SIB 12 03 19

2019-12-30

ENGINE DOES NOT START BELOW FREEZING TEMPERATURES

This Service Information Bulletin (Revision 1) replaces SI B12 03 19 **dated February 2019**.

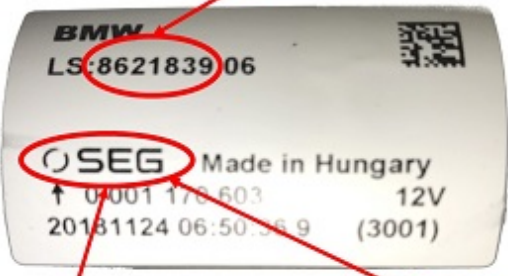
Revised starters are being phased into production between December 2018 and February 2019 depending on the engine and vehicle plant.

1. Identify the starter brand and change index per the manufacturer's label on the starter housing.
2. Replace the starter motor per the Procedure.

<p style="text-align: center;">Part Number</p> 	<ol style="list-style-type: none"> 2. Check which starter motor is installed: <ul style="list-style-type: none"> • SEG label shown, the BOSCH label follows the same layout. • If a Bosch or SEG starter motor is installed, replace it with a Denso unit Part Number 12 41 8 577 010 (confirm the P/N in ETK). <p>Refer to Repair Instructions 12 41 020 "Removing and installing/replacing the starter motor".</p> <p>Original starter P/N for reference:</p> <p>B46O:</p> <ul style="list-style-type: none"> • 12 41 8 621 838 or • 12 41 8 621 839 <p>B58M:</p> <ul style="list-style-type: none"> • 12 41 8 621 840
--	---

3. Note: The noise damping plug P/N 12 41 8 571 350 must also be installed into the replacement Denso starter.
